SIGN BRACKET STORE

PRODUCT DESCRIPTION	SKU			ORDER NUMBER		
50" Triangle Truss Sign Bracket	405B-50					
DIMENSIONS	COLOR	FINISH	REP:	DB:	DATE	ı
	Black powder coat		TESS	NLA	06/2024

BACK VIEW

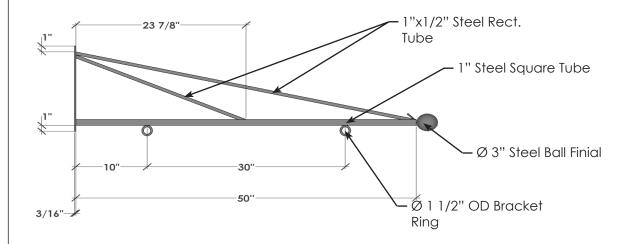
(1) 3/4" O.D Guy Wire @ 45° facing mounting plate on top of bar, guy wire thickness should be 3/16"

GENERAL NOTES							
1. Please add 1 Guy wire ring and need New							
Format
